**IN THE MATTER OF** Applications by the Central Plains  
Water Trust and Central Plains  
Water Ltd. to Take and Use Water  
for Irrigation in the Central Plains  
area.

**Section 42A Officer's Report**

**Report of HOWARD RAYMOND WILLIAMS**

Figure 1: Map showing location of ECan monitoring wells L36/0142 and M36/0202 (Source: Weir evidence, page 78)

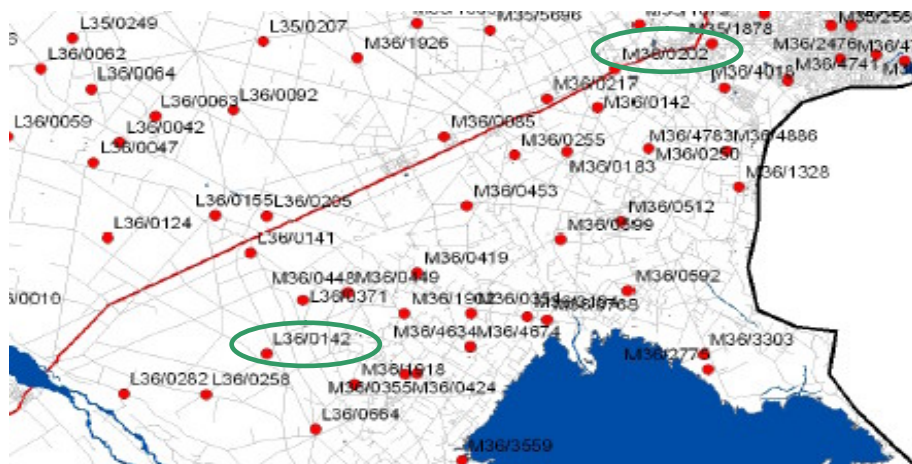
31. I present the following as an indicative example of mounding associated with a dry irrigation year on the back of a wet winter, as actually happened during the 2006-7 irrigation season. I have taken Mr Weir's transient modelling plot of well L36/0142 (Weir evidence: page 80, location map on page 78) and measured the simulated mounding during the early part of the 2006-7 irrigation season (Figures 1 and 2).

Figure 4: Map showing depths to groundwater in a 'wet' year (Source: Weir evidence page 116)

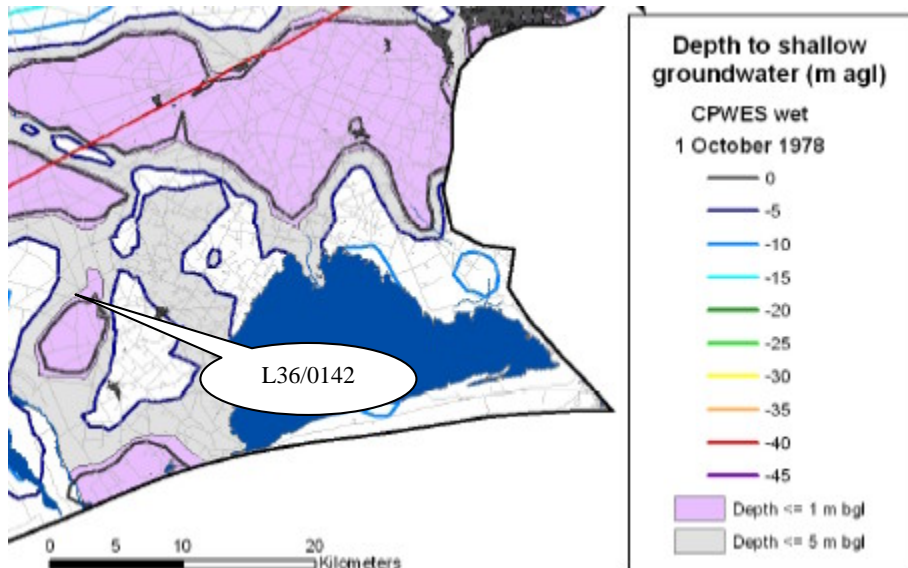
33. The comparison indicates that the 2006-7 'wet year' predicted mounding of ~3 m is nearly 50% greater than that predicted by the model even for a dry year such as at 1st March 1970 (~2 m) as shown in Figure 3. This level of mounding brings the resultant groundwater level to ~48 m amsl<sup>4</sup>, to within about 5 m of the land surface (52.75 m amsl), a value similar to that predicted for that area in the wet year depth to groundwater map on Weir evidence page 116 (Figure 4).

Figure 5: Map showing mounding in a wet year (Source: Weir, page 109)

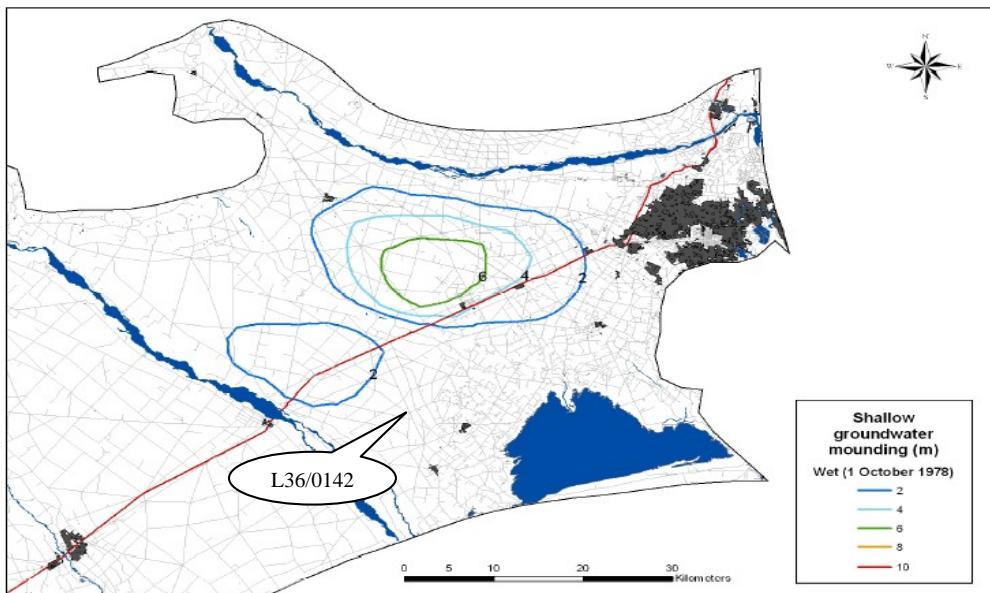
34. However, during the irrigation year 1978-79, chosen as the wet year for the transient modelling, a corresponding mounding of only 2 m is modelled for the summer of 1978-79, but it occurs on the back of much higher late winter groundwater levels, bringing the mounded level to 51.2 m amsl, representing a depth to water below the land surface of only 1.5 m. Comparison of this two metres of modelled mounding at the location of L36/0142, with the plot of wet year mounding (Figure 5, and Weir page 109), shows that the amount of mounding for this location is more than shown on the map portrayed in Figure 5.

35. What the preceding four paragraphs serve to indicate is that whilst I am in agreement with Mr Weir's conclusions that mounding will occur, and with the general disposition of mounding magnitude, I am uncertain whether the mounding scenario for a dry or wet year is a realistic assessment of the worst case scenario.

**Figure 7: Map showing locations of earthquakes (GNS data) and fault locations (ECan, URS and Campbell data)<sup>15</sup>**

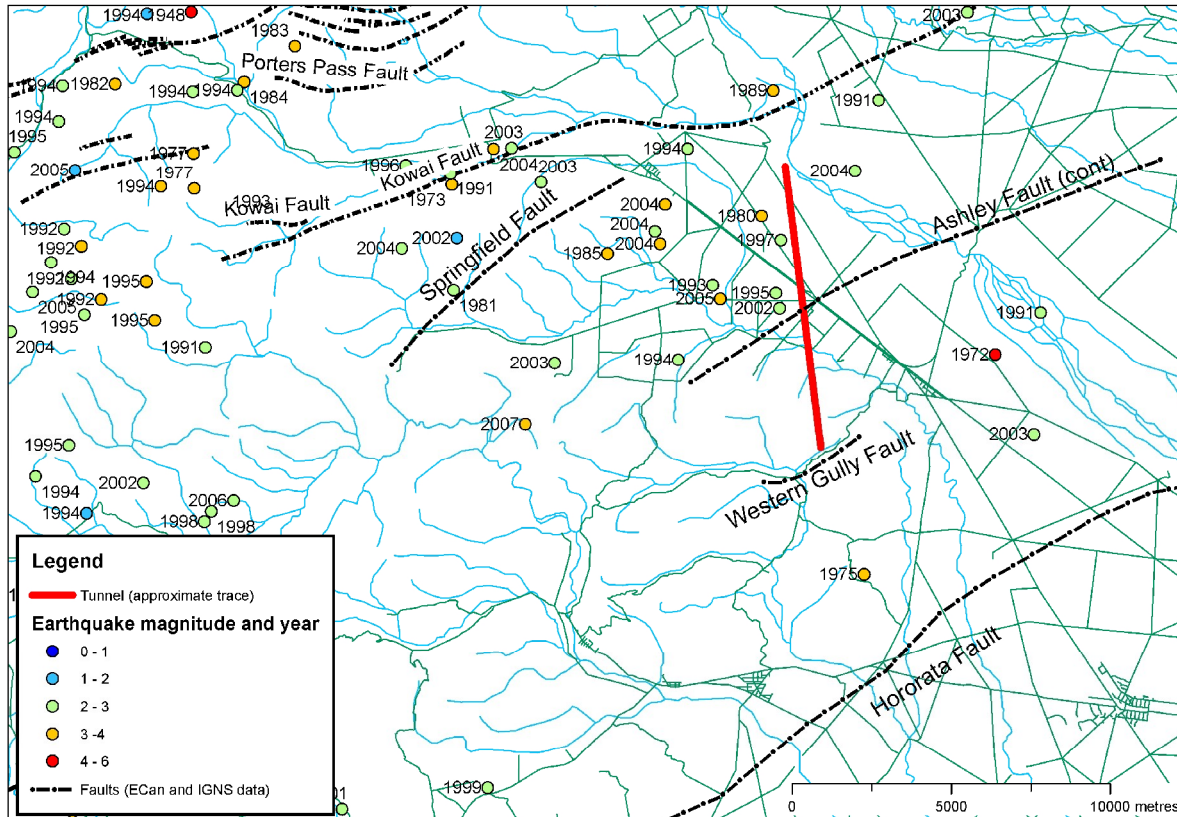
94. I have undertaken a brief analysis of earthquake records (data downloaded from IGNS website in January 2008) for the area and note that there are no recent low Richter magnitude earthquakes in the area occupied by the dam and reservoir (Figure 7).

95. There are earthquakes and a continuation of the Ashley Fault lying along a zone traversed by the tunnel (Figure 7). I do not consider these earthquakes and the fault traversing the tunnel trace as being a major issue in that, at worst, the tunnel might require maintenance should a major slip occur along a fault that crossed the tunnel.
